# **OEHI Responses to March 2012 CEC Data Requests 1-7**

Amended Application for Certification  
for  
HYDROGEN ENERGY CALIFORNIA  
(08-AFC-8A)  
Kern County, California

October 2012

**PROPOSED ENHANCED OIL RECOVERY  
PROJECT  
(Phase I)**

## Elk Hills CO<sub>2</sub> Injection Project (Phase 1)

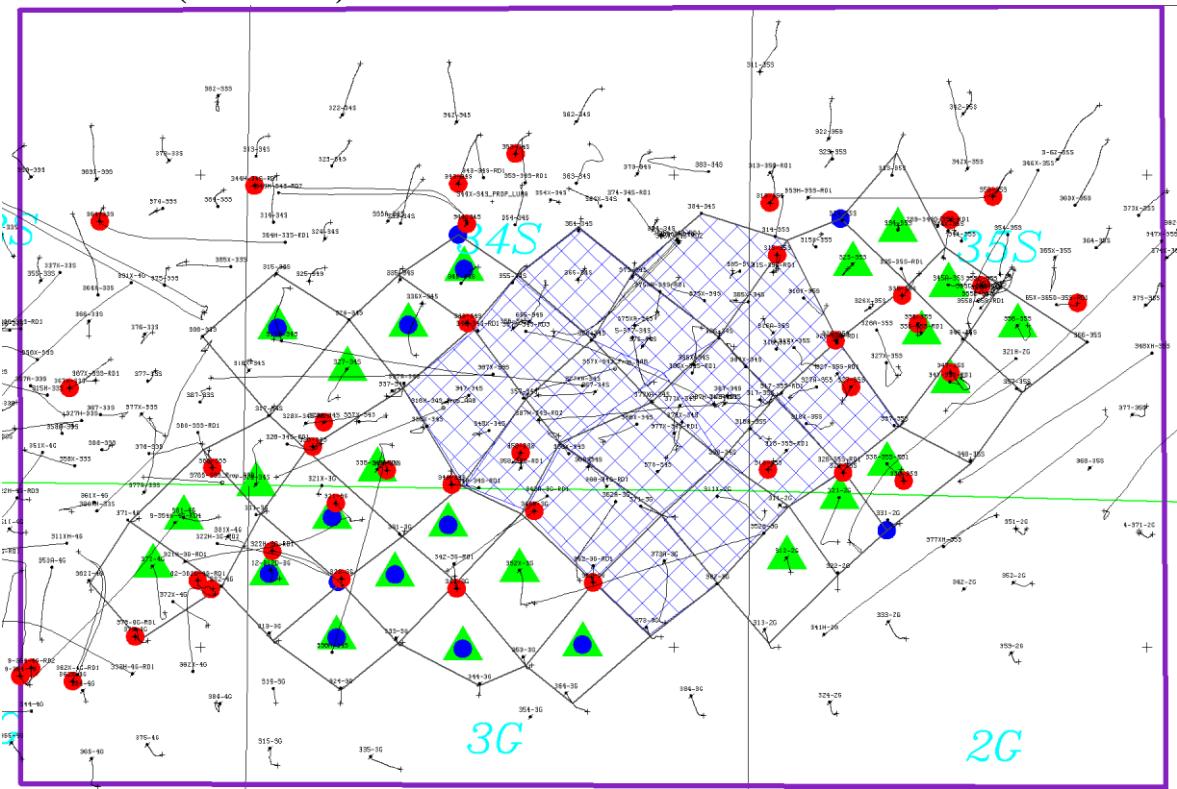
**a. A map showing injection facilities, including the anticipated total number of wells to complete the project and all pipelines.**

Please see attached map of Phase I area injection facilities and overall project pipeline routes. A well-level map is also attached per the response to #2-F.

*Figure 5*

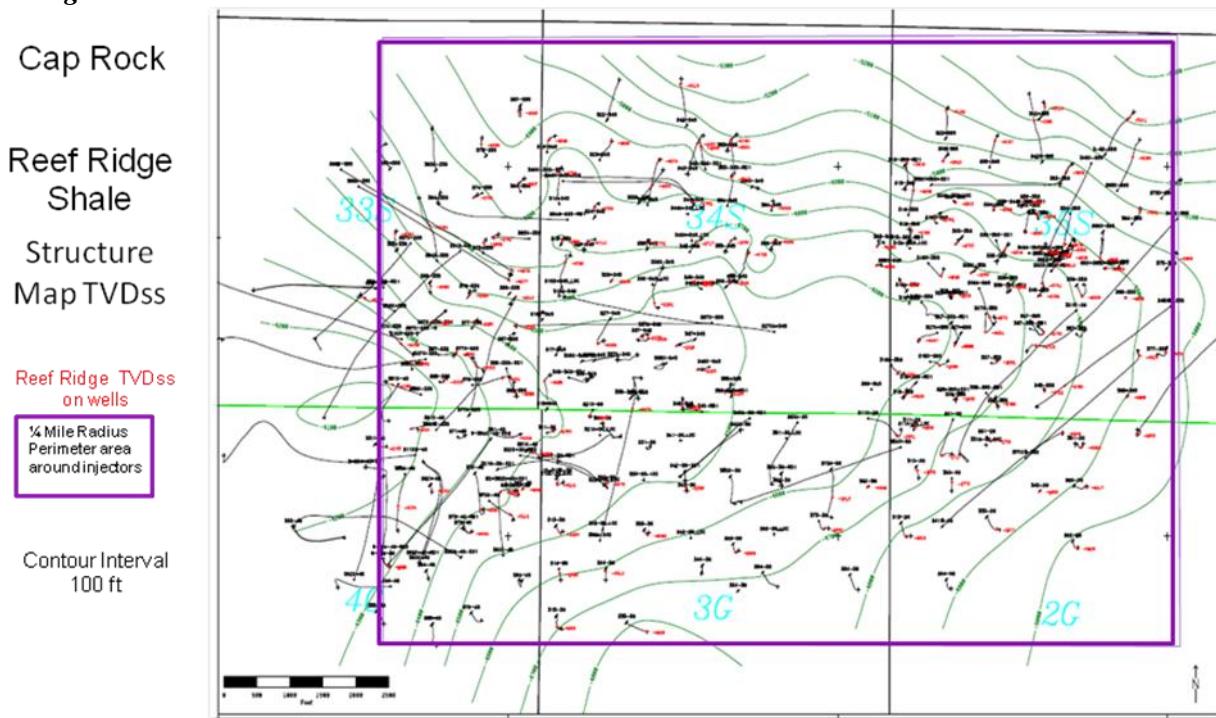
**a. Structural contour map drawn on a geologic marker at or near the top of each injection zone in the project area.**

Please see attached UIC permit application, Section 1724.7 (B), Appendix I.

**Figure 9**

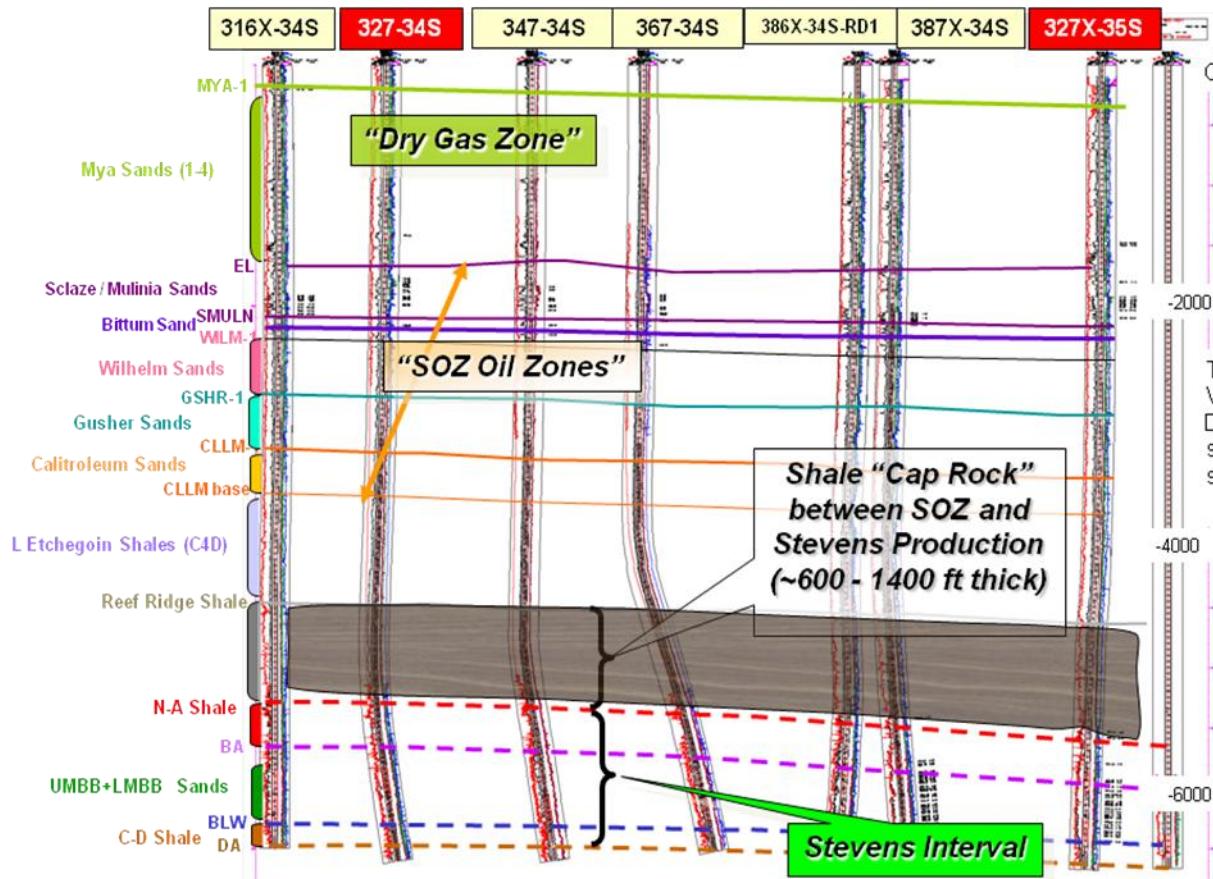
**c. At least one geologic cross section through at least one injection well in the project area.**

Please see attached UIC permit application, Section 1724.7 (B), Appendix I.

*Figure 10*

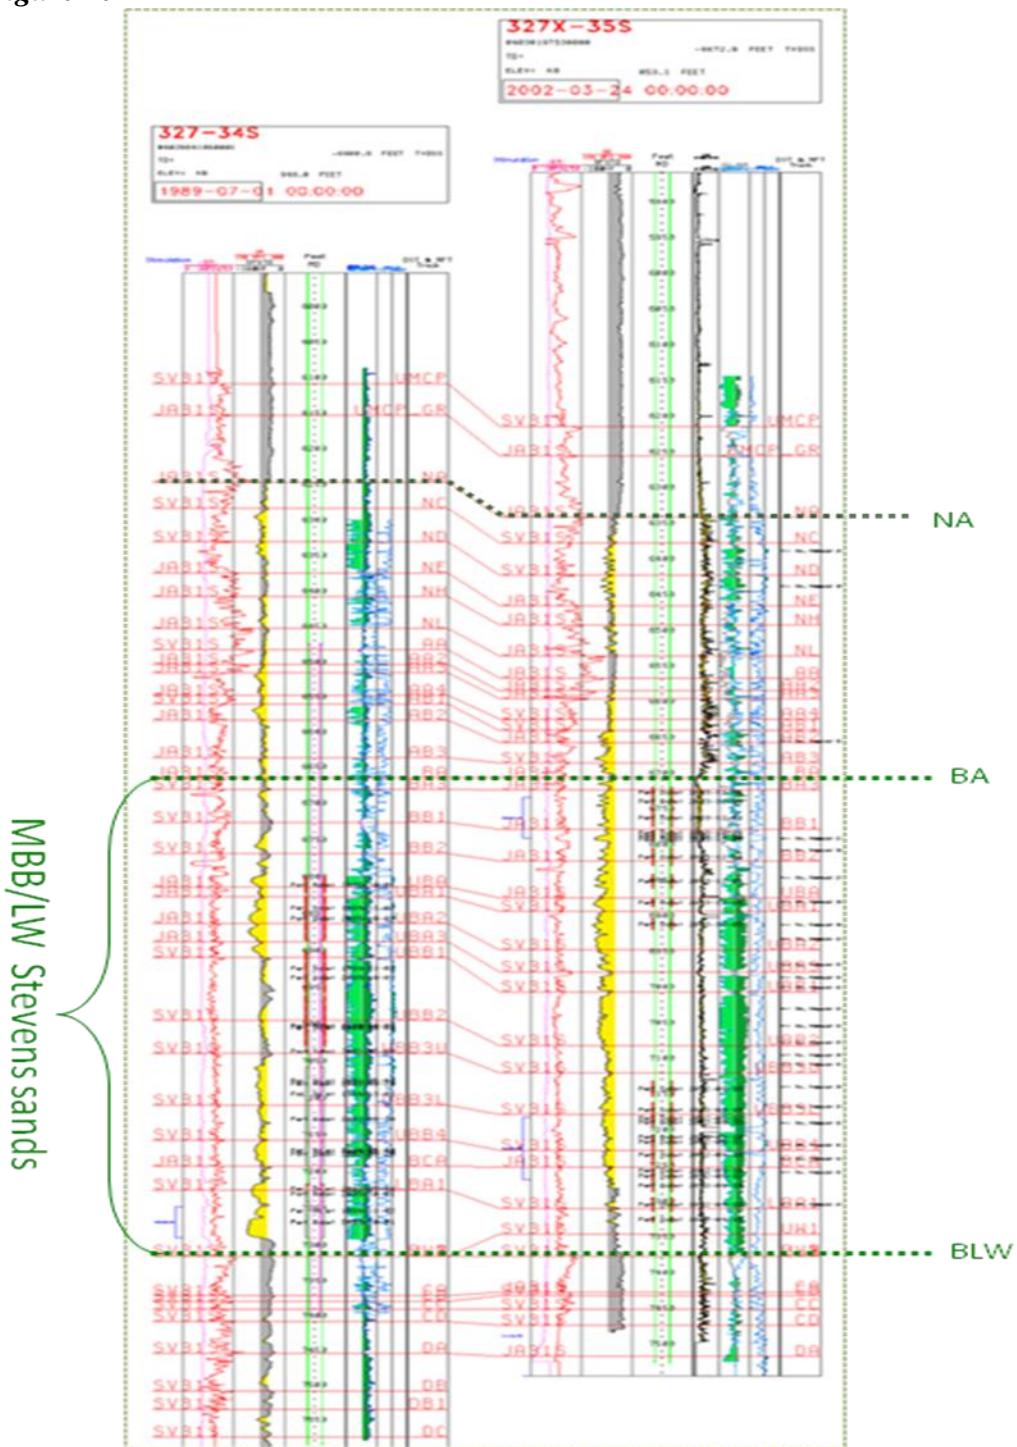
**d. Representative electric log to a depth below the deepest producing zone (if not already shown on the cross section), identifying all geologic units, formations, freshwater aquifers, and oil and gas zones.**

Please see attached UIC permit application, Section 1724.7 (B), Appendix J.
